LiDAR Quality Assessment Report

KS_Area1_2012

KS_25 COUNTIES LIDAR #2

KS-25 Counties Lidar project has 3 Project Areas consisting of 5 lots: Area 1, Area 2 and Area 3 (which is divided into 3 delivery lots). This dataset is Area 1 and encompasses 10 counties in southwestern Kansas: Scott, Lane, Hamilton, Kearny, Finney, Grant, Haskell, Gray, Seward and Meade.

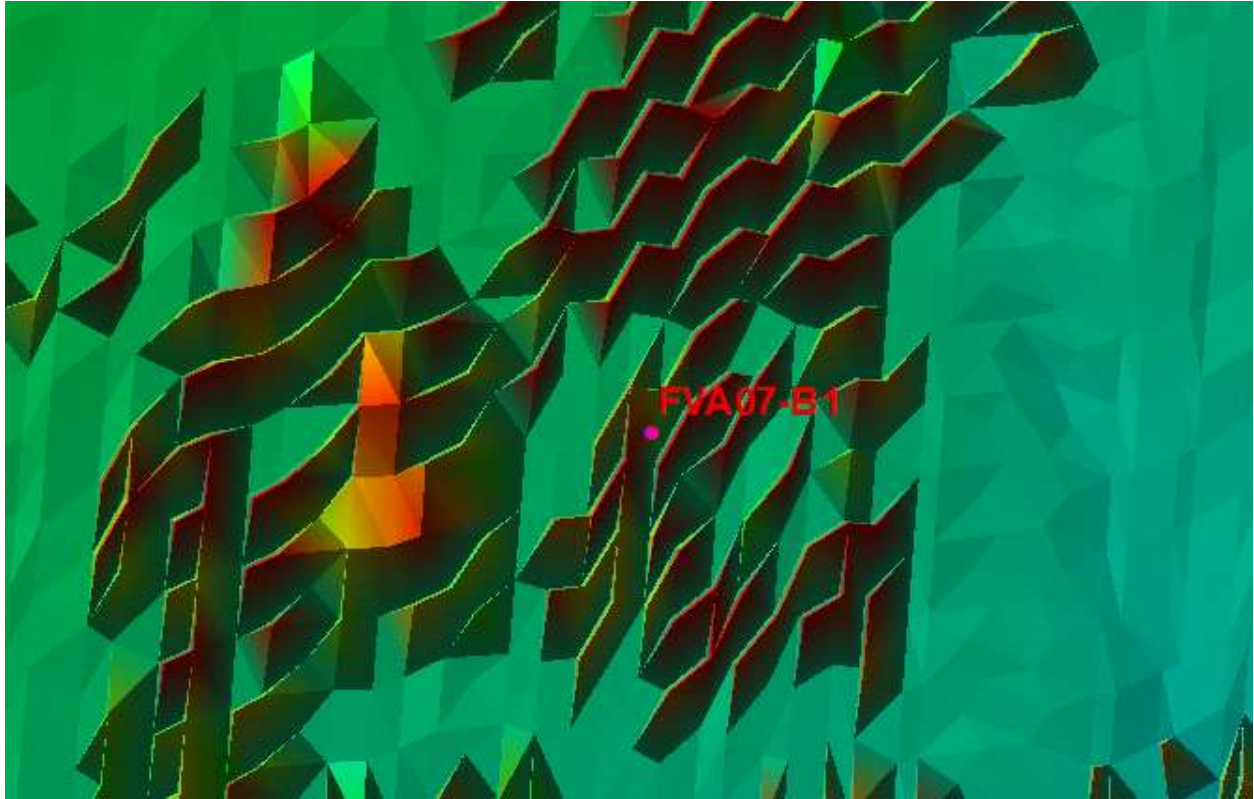
3D profile of survey point FVA07-B1 (in magenta above). The point is located in the

town of Deerfield in an area with tree cover. The point has a z-error of -5.949 meters which indicates that the survey ground elevation is 5.949 meters less than the swath LAS TIN surface elevation.

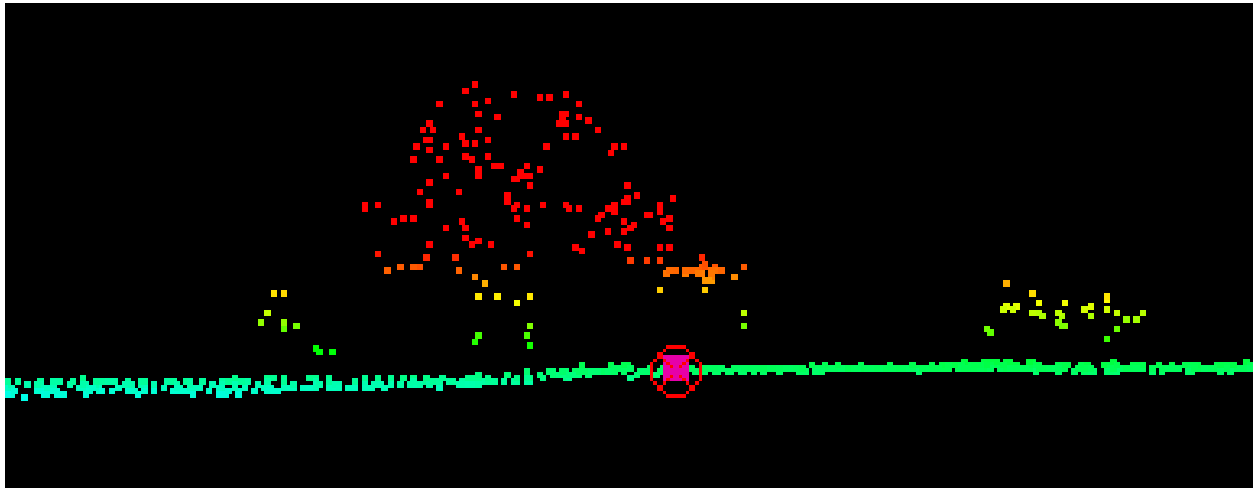
FVA07-B1 survey point on the TIN surface.

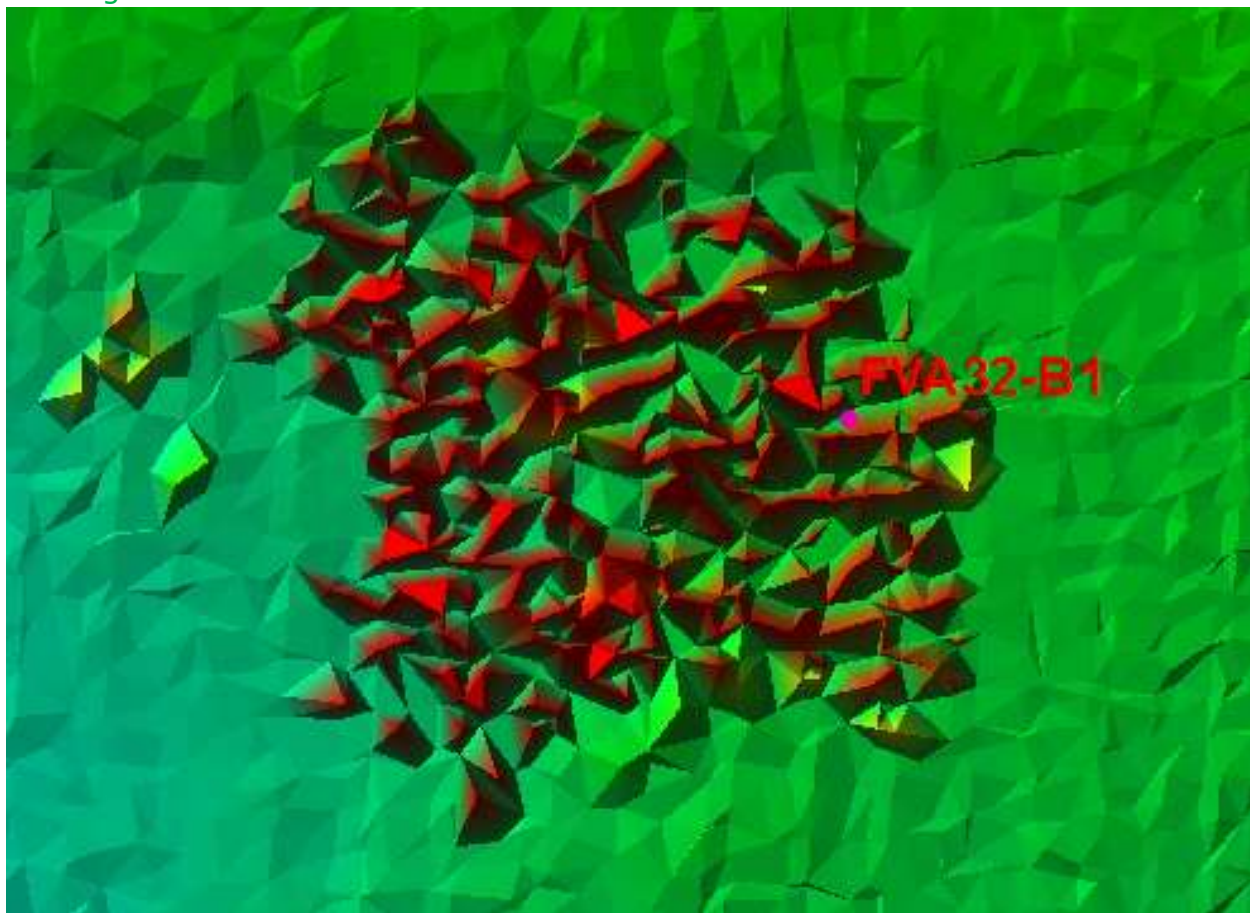
3D profile of survey point FVA32-B1. The survey point had to be removed due to its location in an area of tree cover. The point has a z-error of -0.701 meters.

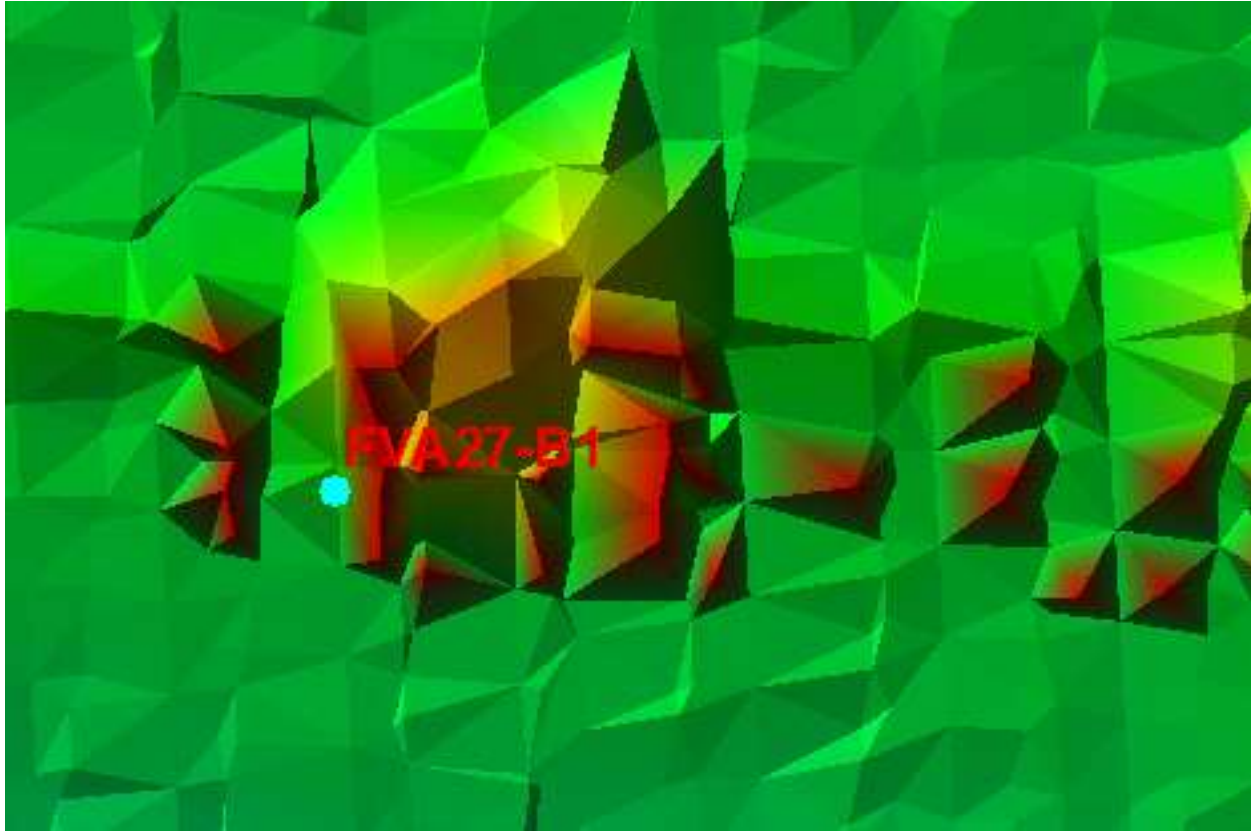
3D profile of survey point FVA27-B1. The survey point had to be removed due to its location in an area of tree cover. The survey point has a z-error of -0.542 meters.

Image showing the TIN of the swath LAS points and the location of the removed point FVA27-B1.

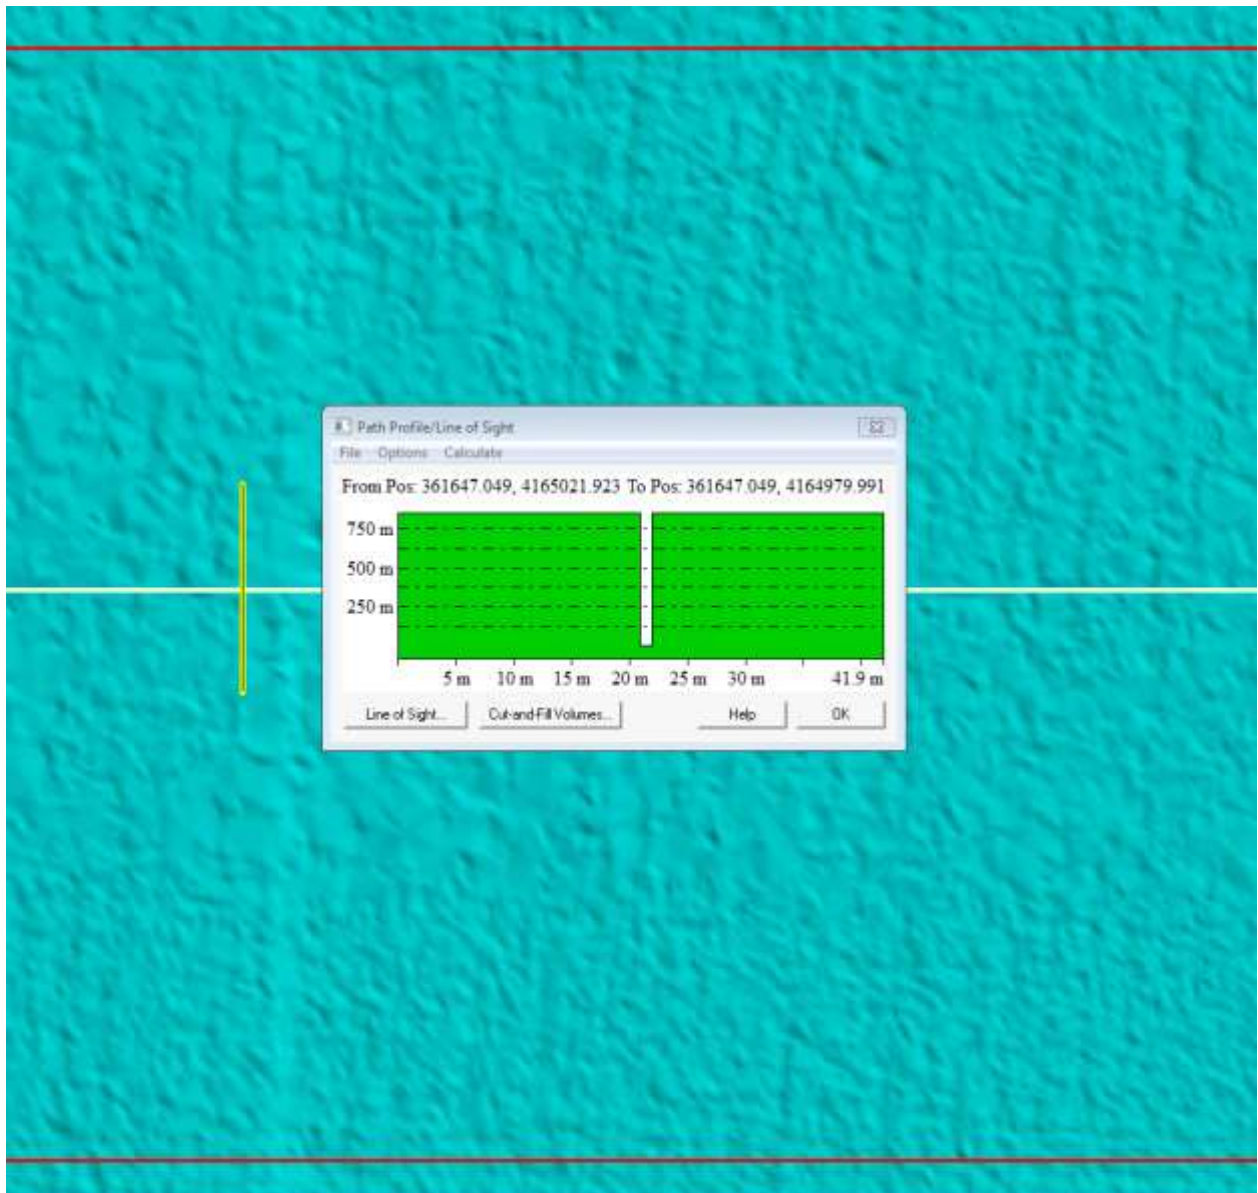
19 errors in which culverts have been removed. This is a representative image.

**8/2/13 Four of the culverts were corrected by the contractor. The remaining 15 errors, the culvert was completely removed. Culverts are to remain in the data per the V13 specifications.

**12/18/2013 Contractor corrected all culvert errors. Culverts were put back into DEMs.

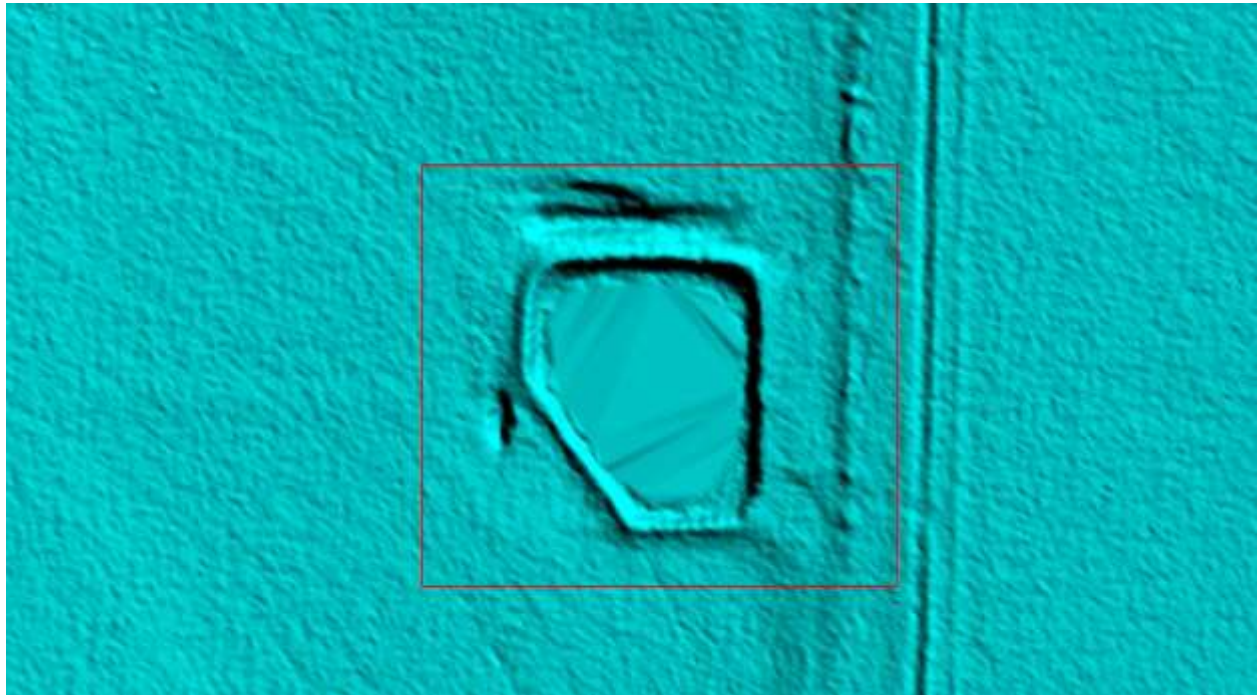
There are two Data gap errors in Block 8 that follows tile boundaries. Locations at 37° 37' 18.9419" N, 100° 33' 24.8270" W and 37° 48' 8.9936" N, 100° 31' 1.5398" W

**8/2/13 The two data gaps were corrected by the contractor.

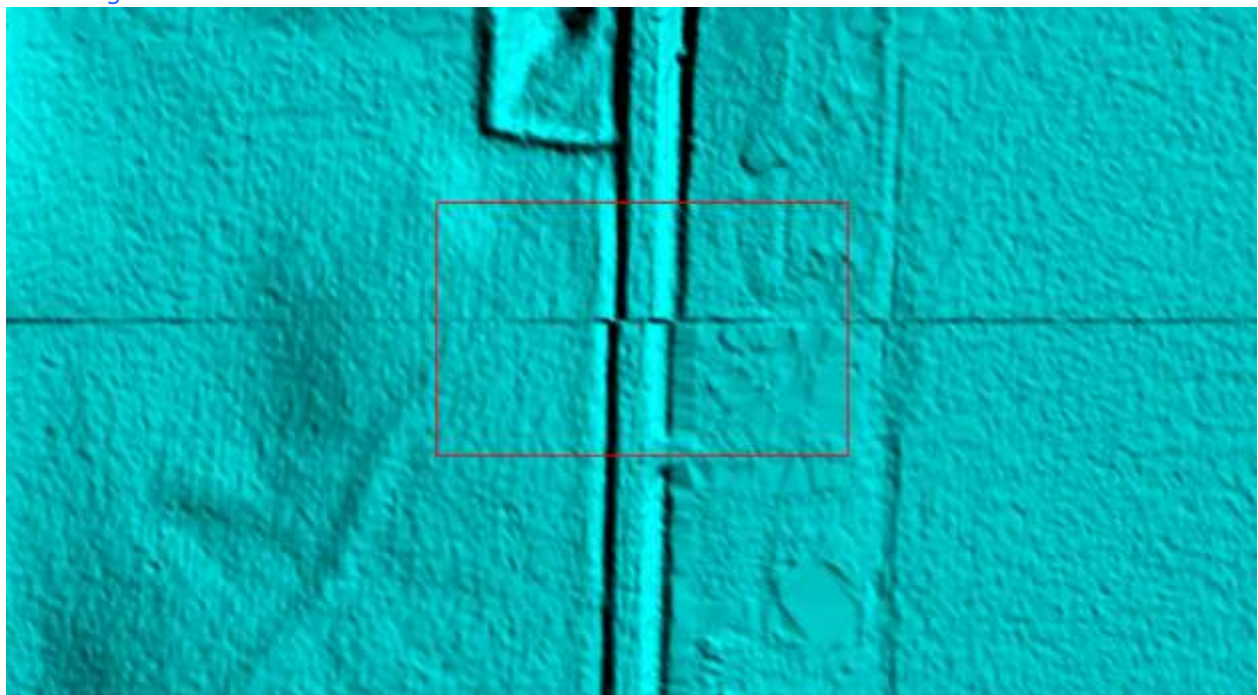
4 errors in which water body is greater than 3/4 of an acre and needs to be hydroflattened. This is a representative image.

** 8/2/13 The four hydroflattening errors were corrected by the contractor.

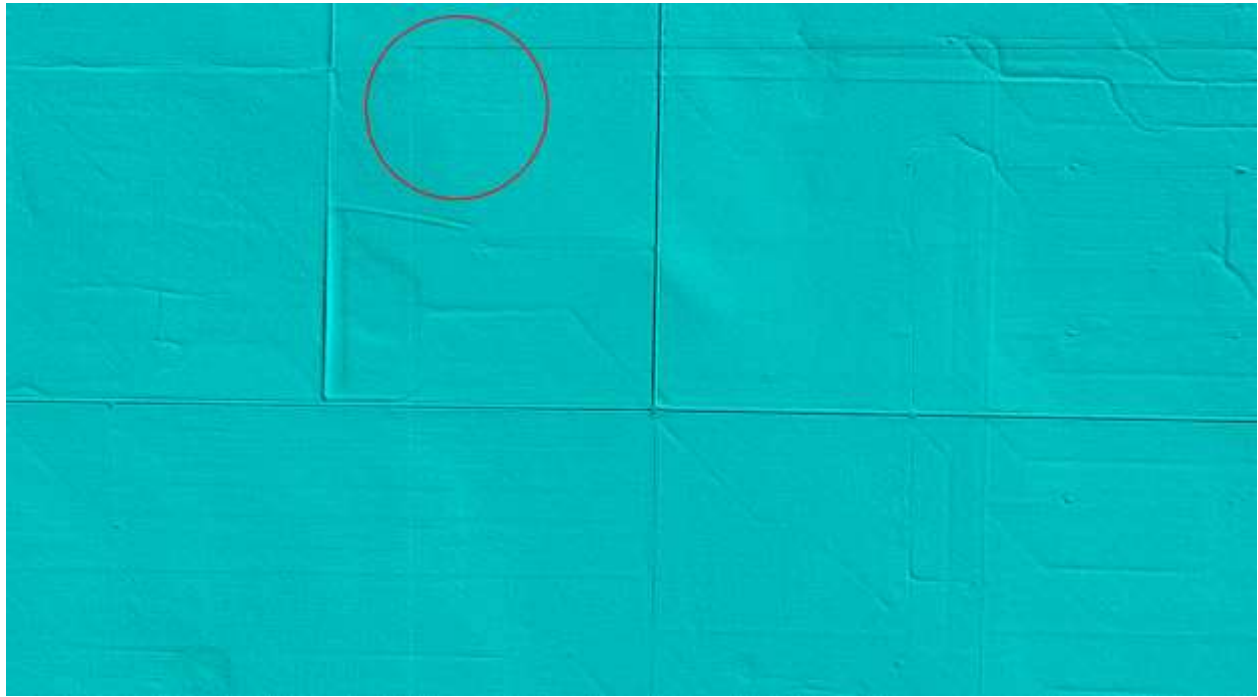
Several places along tile boundaries have a slight shift in the data where they are joined. A check of the tile boundaries is needed to correct shifts in data.

**Corrected by contractor
